# Access Compliance Report

## Public Rights-of-Way

Intersection ID: 14615	Main Street: MCMANUS_DR	Cross Street: ROSEHAVEN_DR	Location: NE
ADA ID: F3F0F74E2A03	Ramp Type: BlendTrans1	Initial Pass/Fail: Fail	Overall Compliance: No
		Severity Score: 10

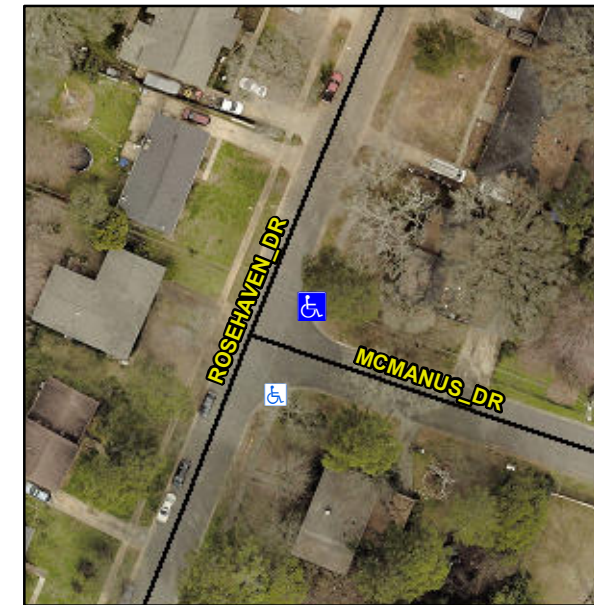
**NO RT SW**

**Not Found, R304.5.1, R304.5.3**

**Remove & Replace Curb Ramp With Two New Directional Ramps or Equivalent.**
